Strathfield Internal Development Assessment Panel Meeting

Friday, 3 April 2020

TO: Strathfield Internal Development Assessment Panel Meeting - 3 April 2020
REPORT: IDAP – Report No. 1
SUBJECT: DA2019/186 31 HOWARD STREET, STRATHFIELD
LOT 207 DP 15259
DA NO. 2019/186

Proposal: Section 4.55(1A) Modification Application to amend external façade treatment, window schedule, and first floor internal layout.

Figure 11: Section plan.

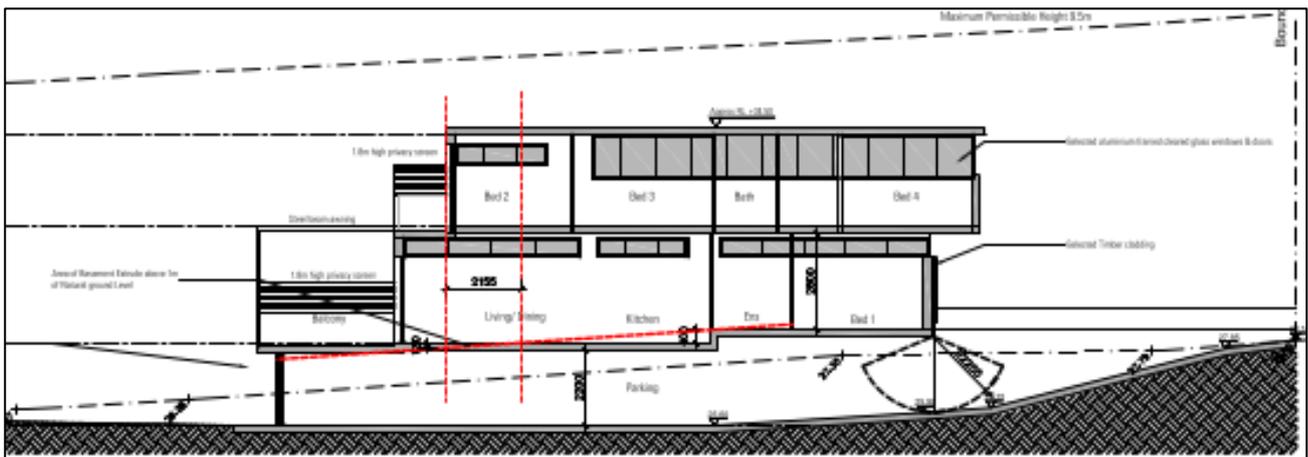
Comments: The proposed basement protrudes more than 1m above the natural ground level and as such does not constitute as a basement in accordance with the definition of a 'basement' under the SLEP 2012 (Figure 11). Consequently, the proposal results in a three (3) storey dwelling contrary to Section 4.2.2 above. The building envelope is considered incompatible relative to the natural ground level and does not appropriately respond to the topography of the site. Whilst the streetscape elevation of the dwelling presents as a two (2) storey dwelling. The design of the dwelling has not been designed in response to the topography of the site and consequently the western elevation presents as a three (3) storey dwelling (Figure 12).

Figure 12: Proposed western (rear) elevation

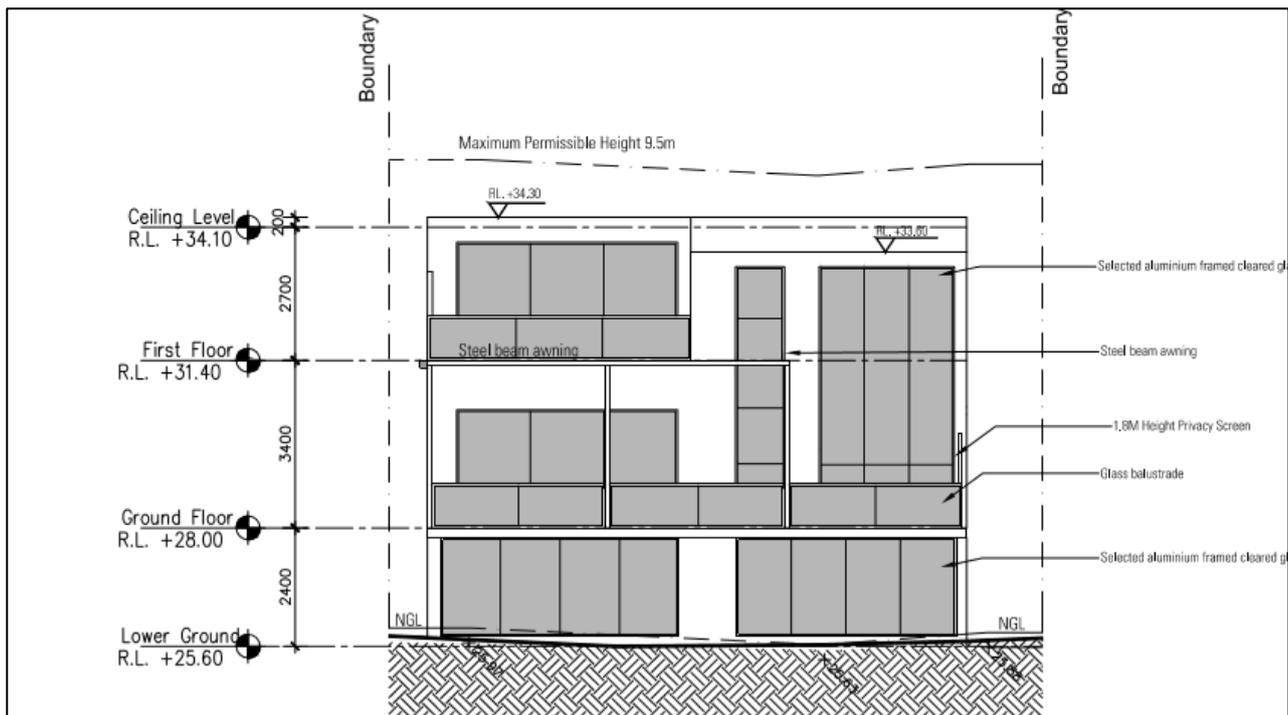
The proposal incorporates floor to ceiling heights of 2.7m to Bedroom 1 on the ground floor and 3.2m to the remainder of the ground floor level. The floor to ceiling height of the first floor level is 2.7m. The 3.2m internal floor to ceiling height of the ground floor is contrary to the 3.0m development control and is unnecessary. The proposed maximum height of the external walls (measures from the existing ground level to the underside of the eaves) is 7.21m contrary to the development controls.

Figure 5: Proposed first floor plan (with modifications outlined in blue)

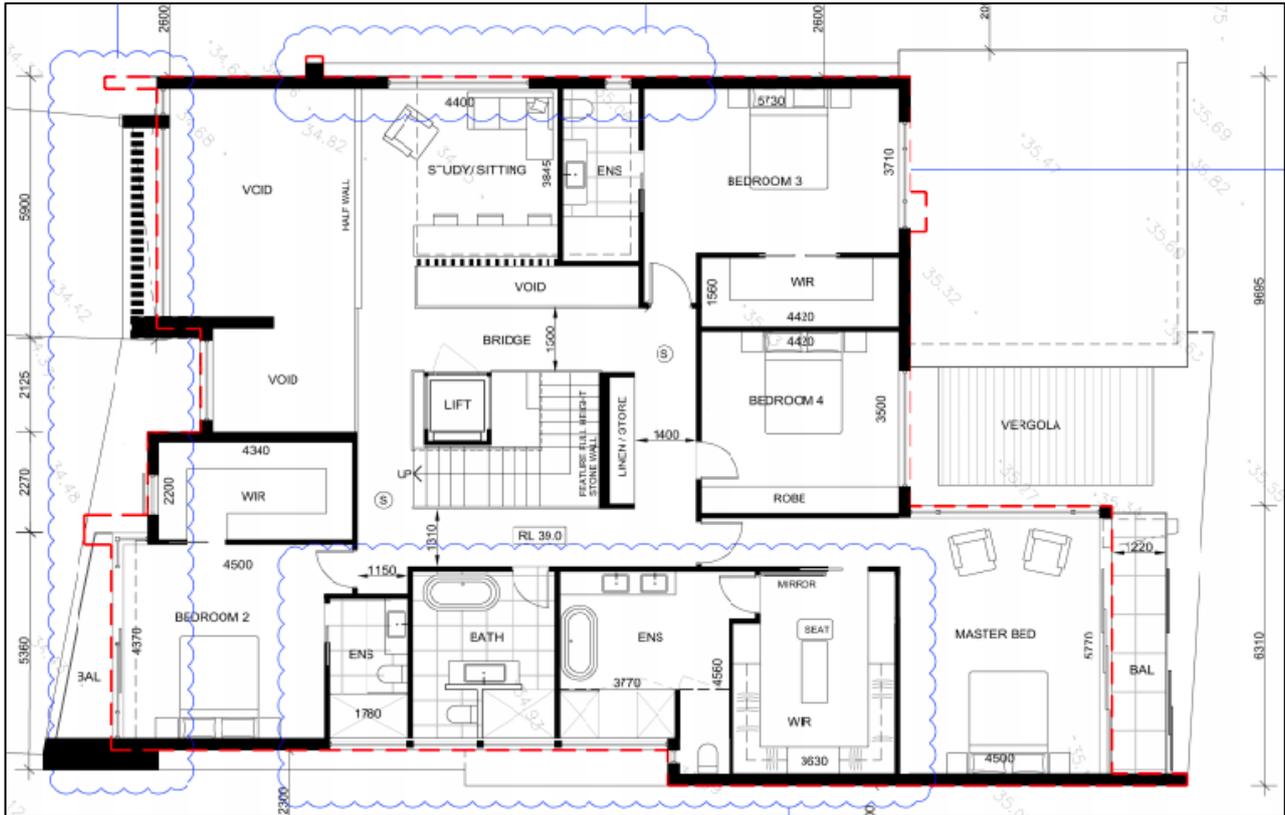
- Remove privacy screen along western elevation;
- Relocate Bedroom 3 window from western (side) elevation to northern (rear) elevation;
- Treat ensuite window along western (side) elevation with obscure glazing;
- Change study/sitting room windows to highlight windows with dimensions 2900mm x 1200mm and a sill height of 1800mm;

The modification application seeks to remove the privacy screen along the western side elevation. The removal of this privacy screen is considered to be appropriate as the study room window will have a sill height of 1800mm from FFL. A condition was also imposed under the original consent requiring all west facing windows to be obscured. In this instance, a privacy screen is no longer required as all west facing windows have been appropriately treated and located to reduce direct overlooking opportunities. The condition has been re-worded to exclude the Bedroom 3 window as this window has been relocated to the north rear elevation.

Council's Response: A condition has already been imposed under the original consent which requires all first floor west-facing windows to be obscure glazed. Bedroom 3 has also been relocated to the rear north elevation.

Figure 19. Basement level with north-western portion to be deleted (shown in red)

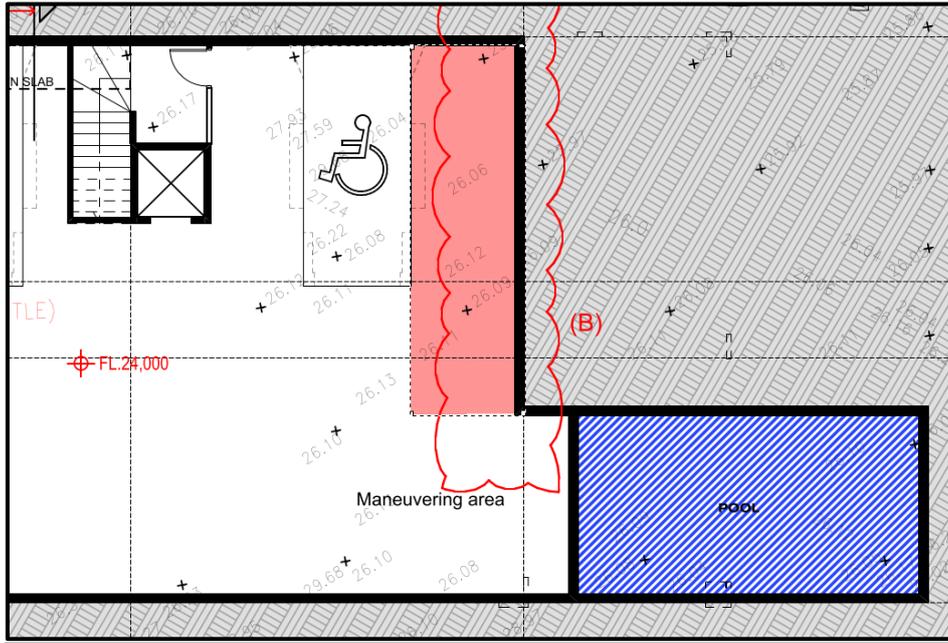
The amended basement level appears slightly excessive and a further reduction can be issued. Conditions are recommended to further reduce this basement level at its north-western extent and to ensure a maximum clearance (floor to ceiling height) of 2.2m is provided (refer to Figure 19). This minimises any necessary excavation, reduces the basement level footprint, and ensures the basement level is not utilised for habitable purposes.
